AW-95-908

November 30, 1995

SUBJECT: WESTINGHOUSE RESPONSES TO NRC REQUESTS FOR ADDITIONAL
INFORMATION ON THE AP600

Figure 440.492-25 NOTRUMP - Elevation of Subcooled Liquid for Test SB10

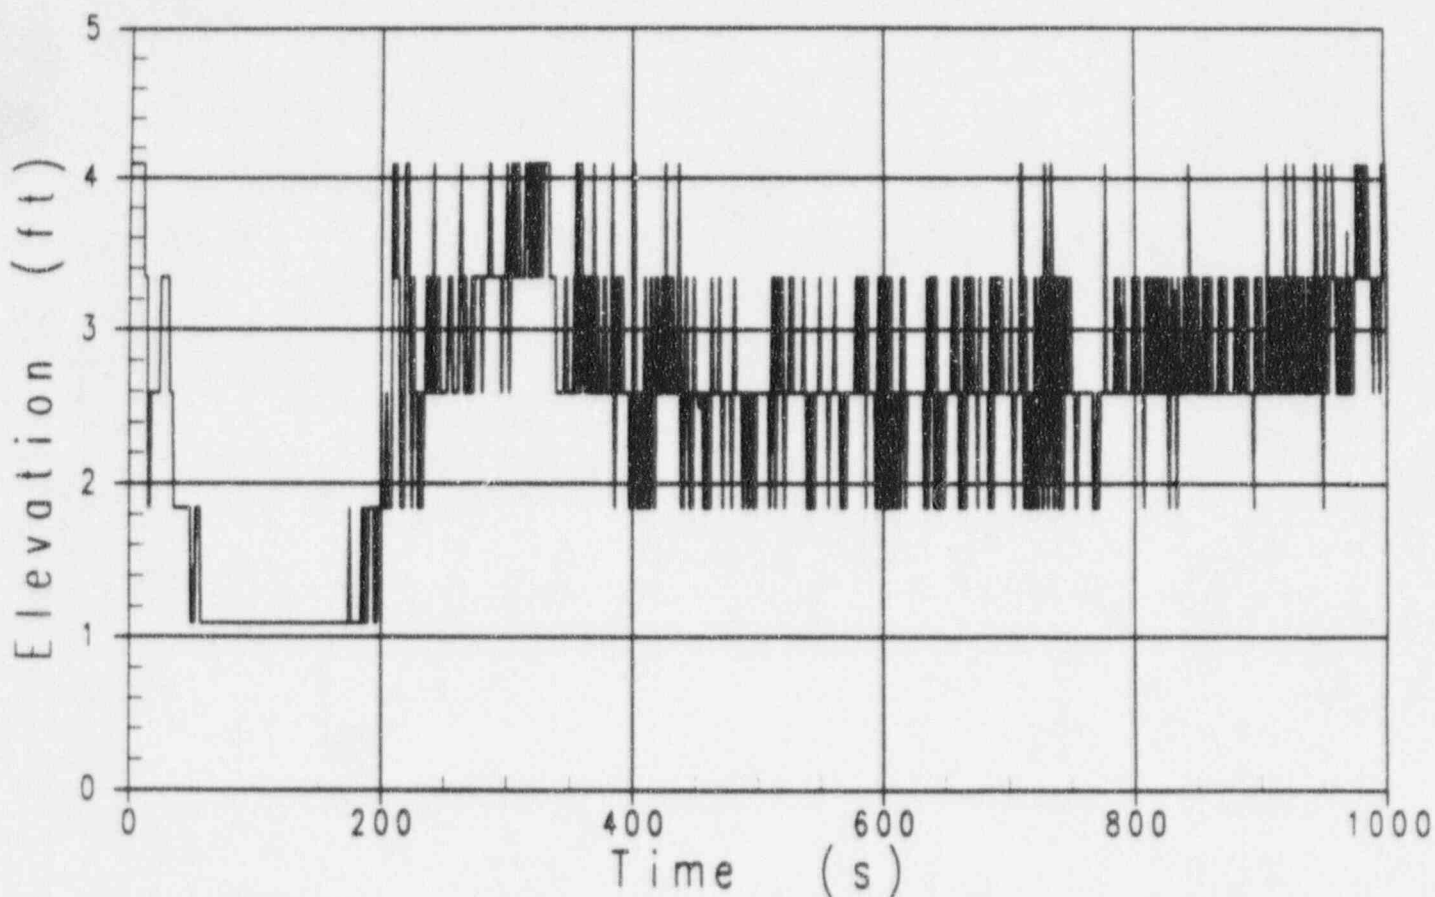
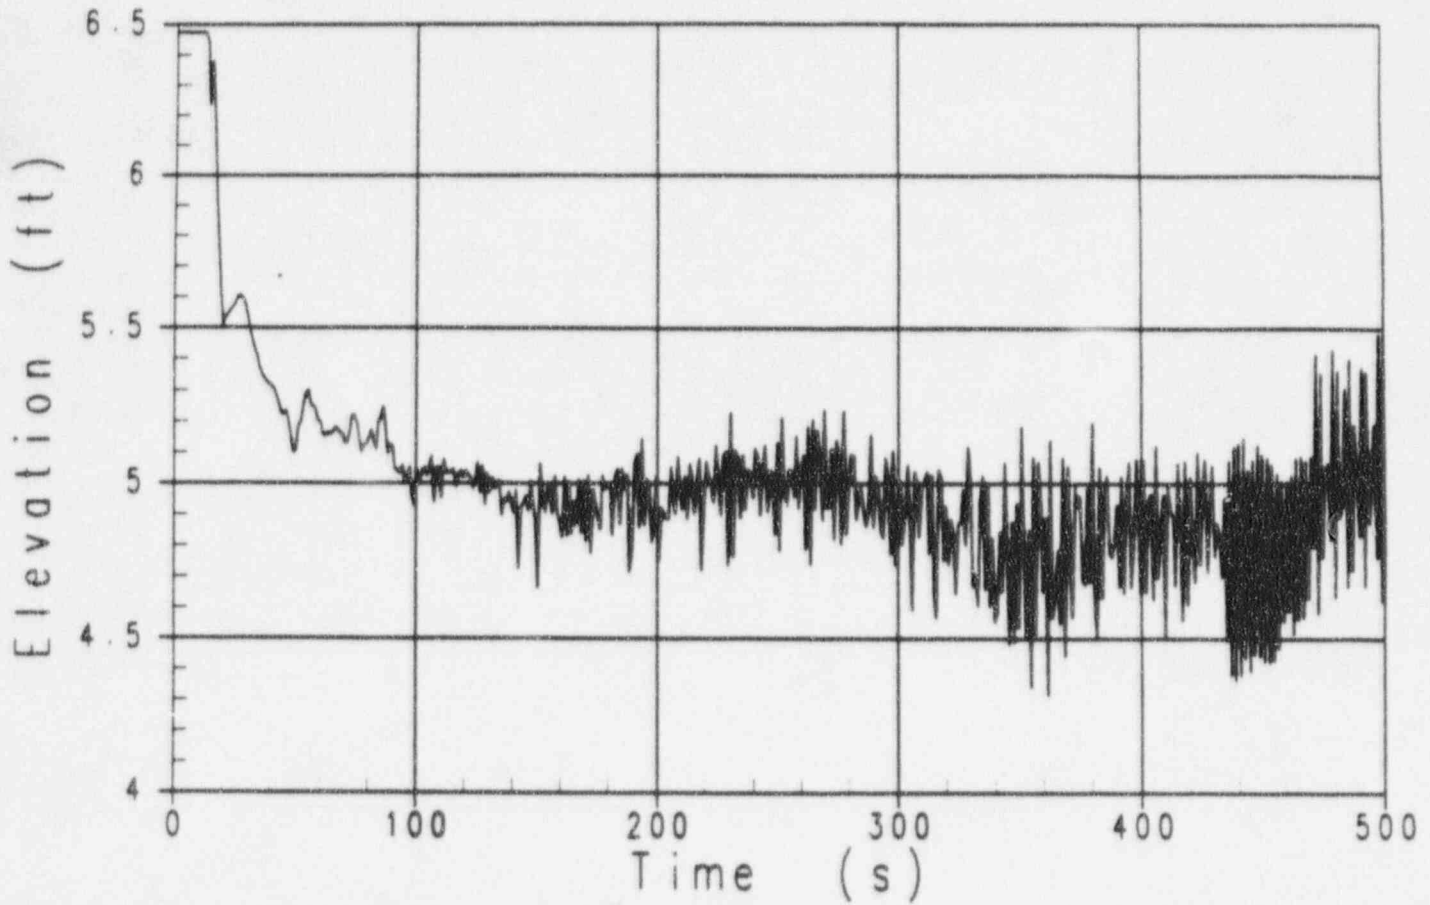
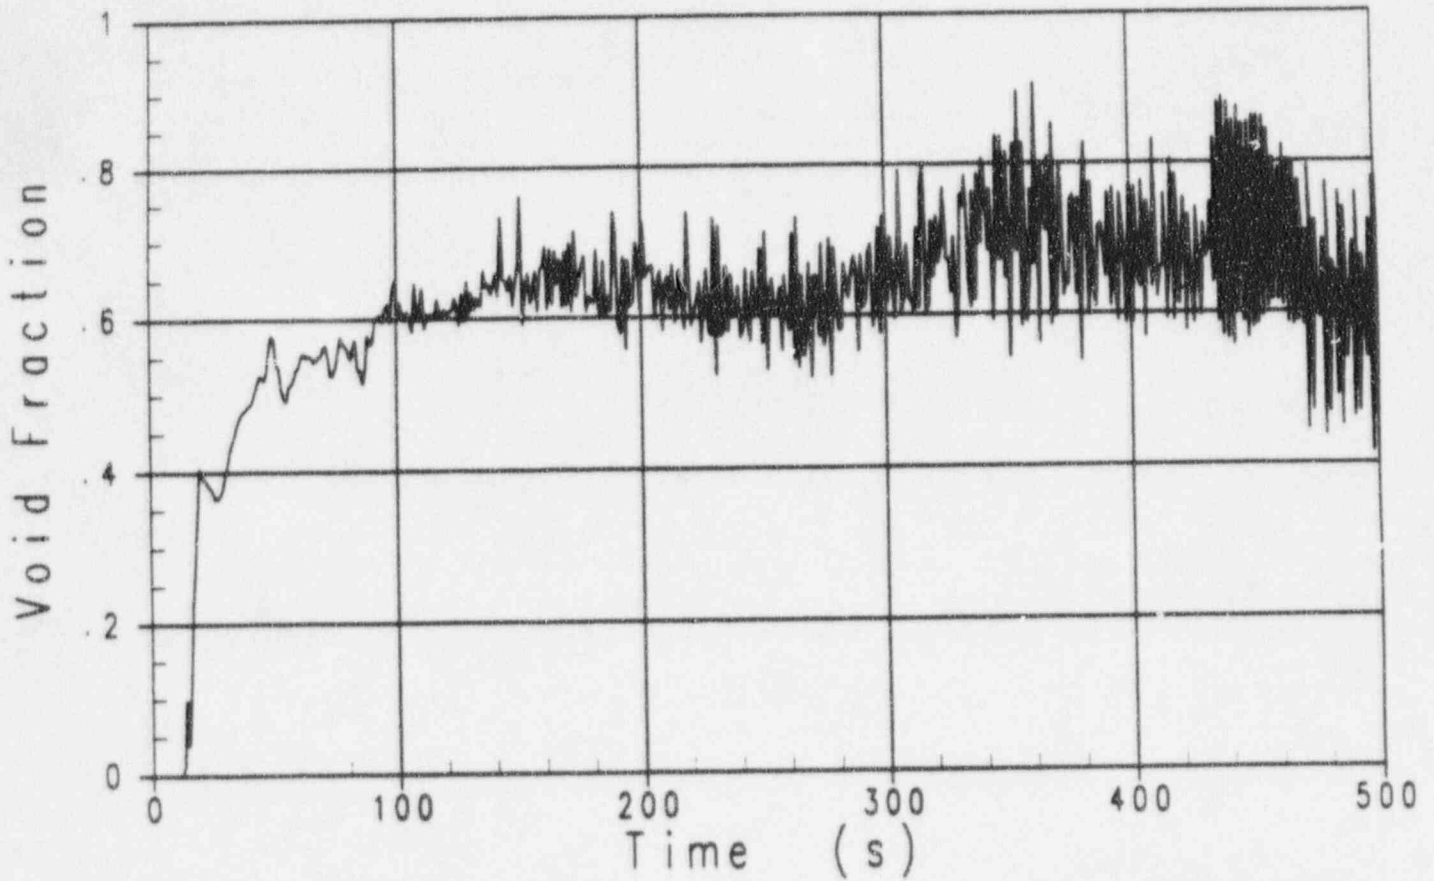
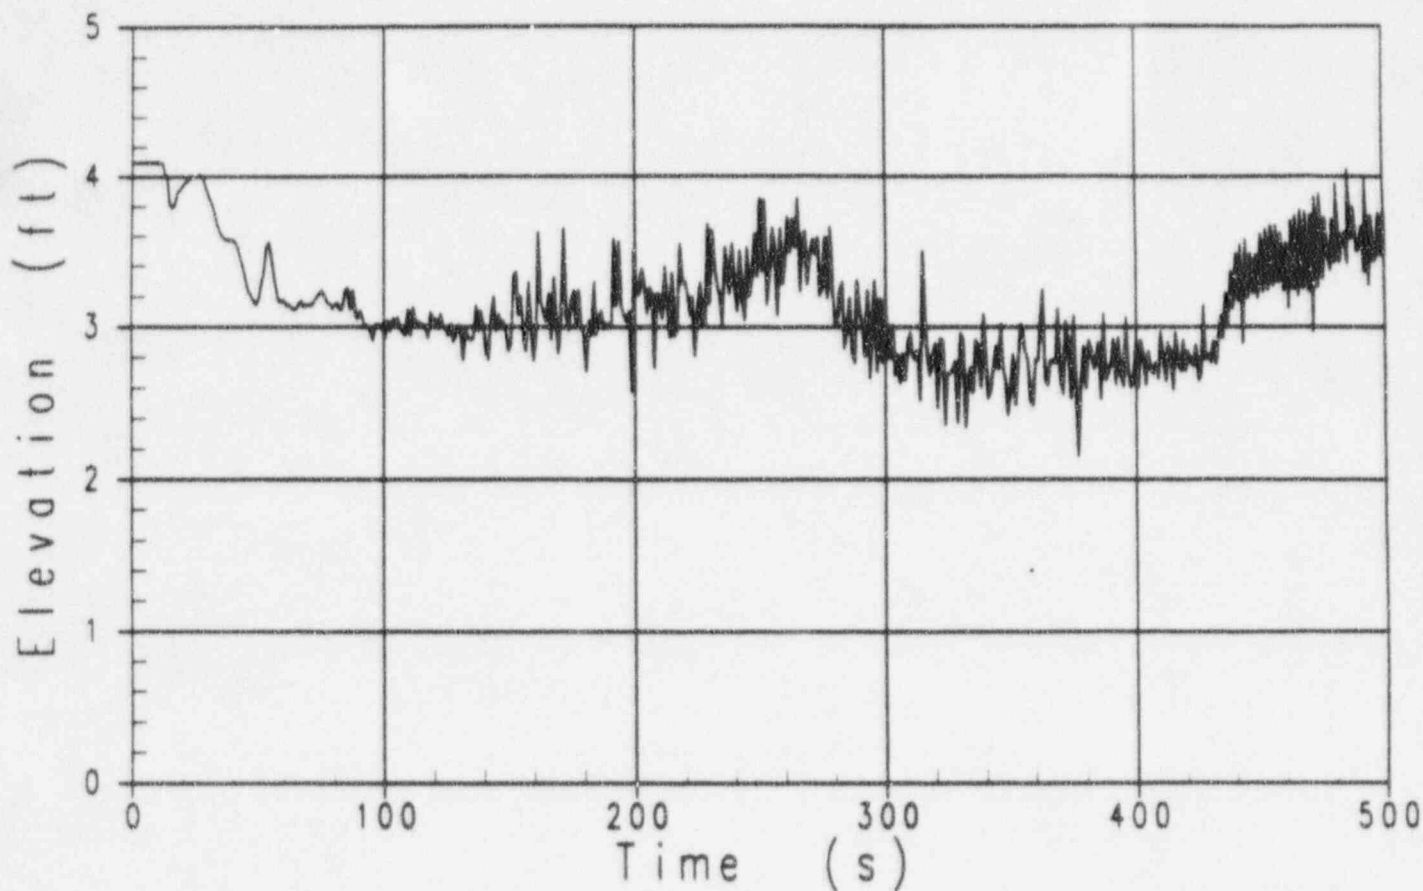
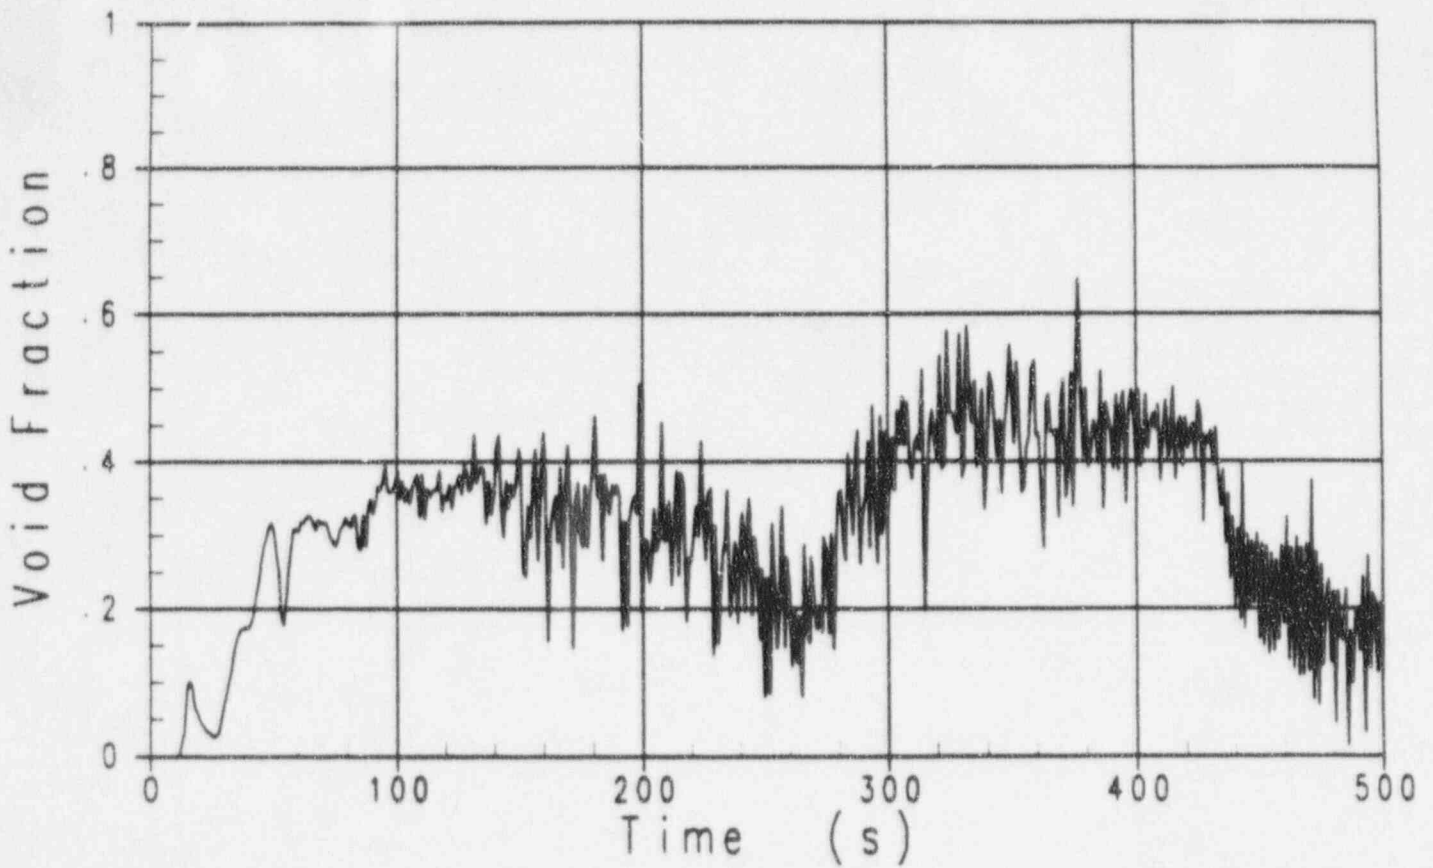
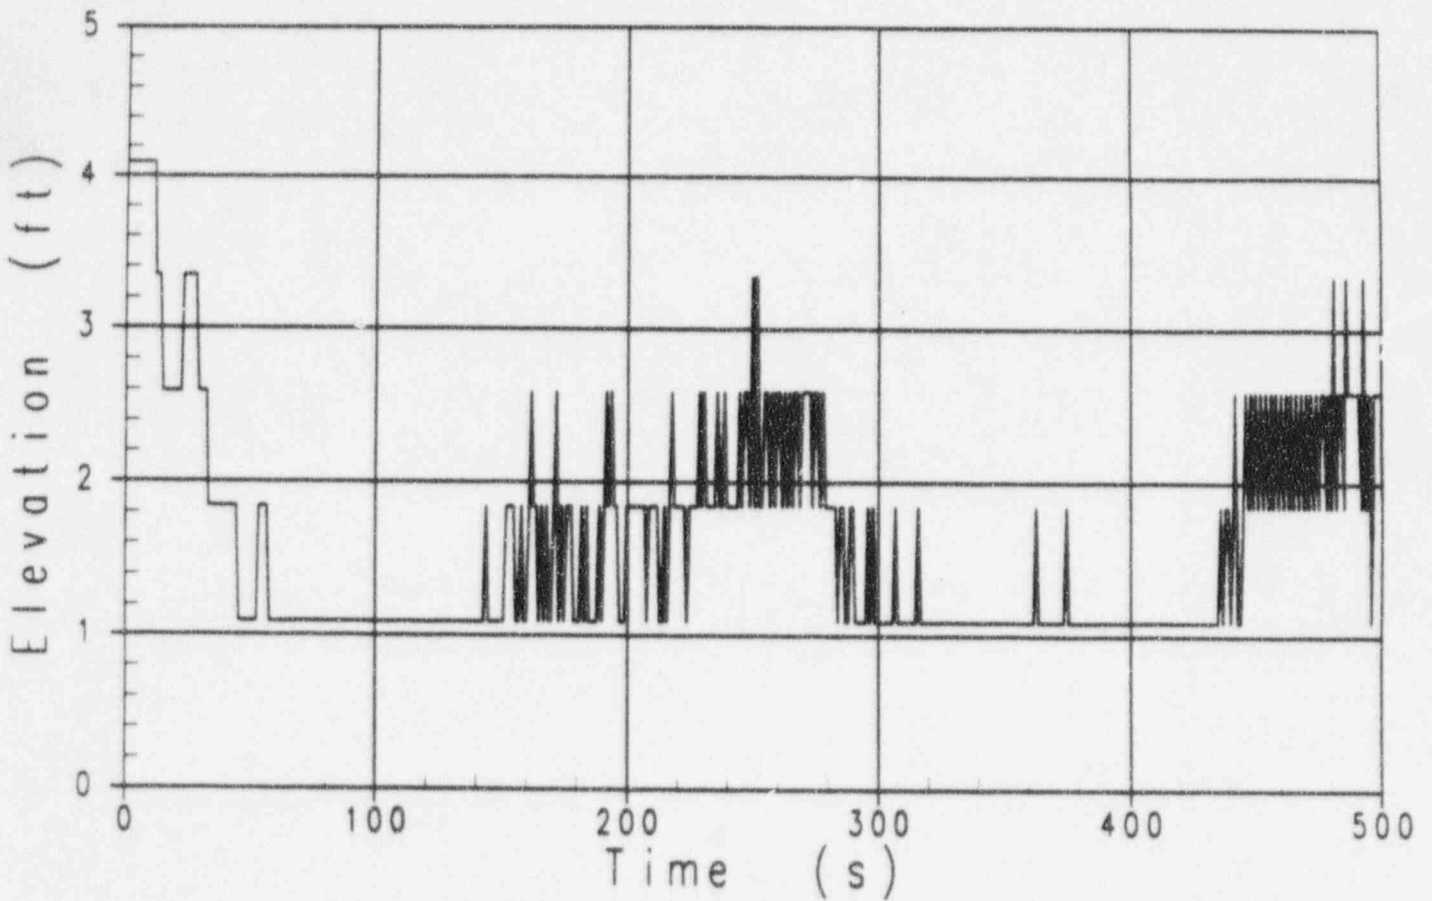
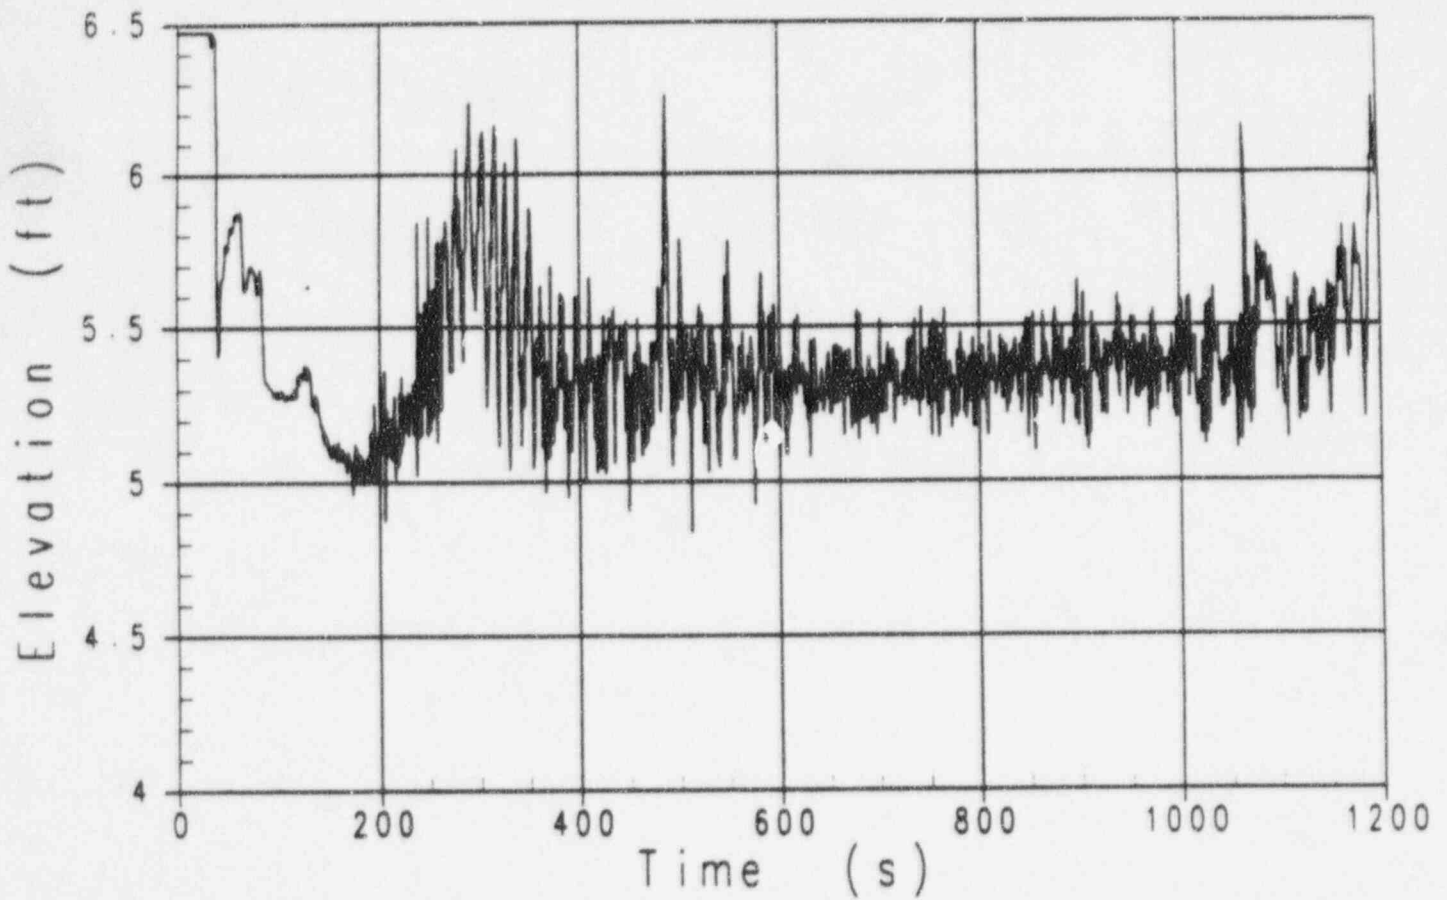
Please provide the core inlet and bypass mass flow rate predictions for the blind two inch cold leg balance line break of Section 5.2. Also, provide the liquid level plots for the upper plenum and core region and the void distribution in the core region.

The requested NOTRUMP core inlet and core bypass mass flow rate predictions for this test are provided in the response to RAI 440.491.
